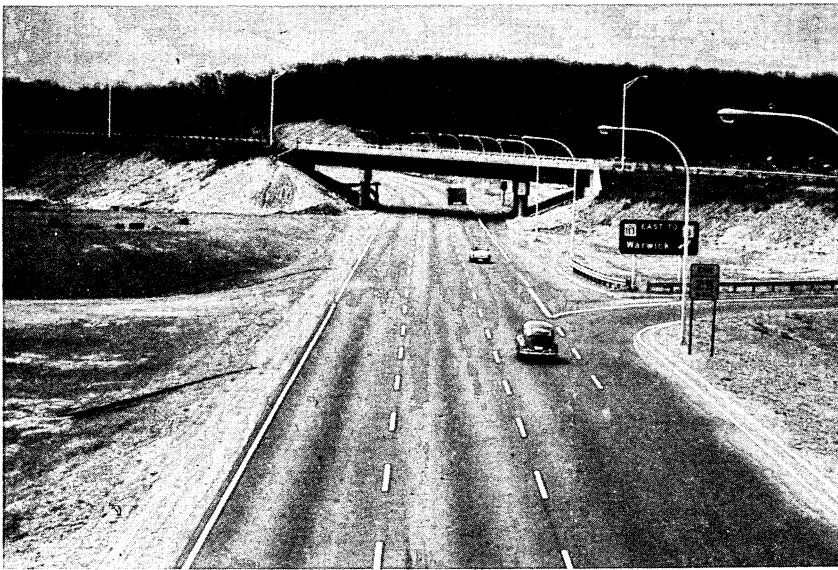
Here is still another gore where there is a very abrupt takeoff, 25-mile-an-hour curve to enter that, and there is need for additional material to fill this depression if that gore is preserved.

Mr. PRISK. Desirably, exit speed should be .7 or .8 of the design speed. And design speeds—I do not know that I fully understand the concept of design speed except it is something to govern the geometrics and superelevation, curvature, by. But beyond that its meaning is a little mystic to me.

If you figure that our sections through urban areas are designed for 50 miles an hour, as is required by the Interstate standards, .7 would, of course, permit you to have a 35-mile-an-hour exit at this point. This puts this a little bit low, a little bit sharp.

One think that has happened here is you have a skew crossing and this roadway is coming up closer to the camera here than it is down here [indicating]; and for that reason, without a considerable amount of right-of-way here, it would be hard to get a 40-mile-an-hour takeoff.
